CONTRACT CHANGE ORDER NO. ____
SHEET ___ OF ___

MARK	DATE	DESCRIPTIONS	BY	CH'D	CCO#
2	11/08/11	CABLE RAILING	DT	MN	188
1	09/01/11	EAST END OBG	GB	MN	87

SAN FRANCISCO OAKLAND BAY BRIDGE
EAST SPAN SEISMIC SAFETY PROJECT
SELF-ANCHORED SUSPENSION BRIDGE
(SUPERSTRUCTURE & TOWER)

EAST SADDLE HOUSING DETAILS NO. 1

ALTERNATIVE SECTION A-A (See Note 7)
1:40

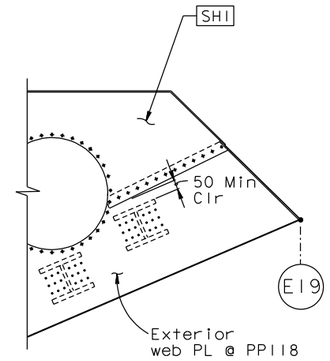
6. For cable railing details, see "Typical Girder Details No.17A" sheet. (△2)
7. At the Contractor's option, it is acceptable to use "Alternative Section A-A" in lieu of Section A-A".
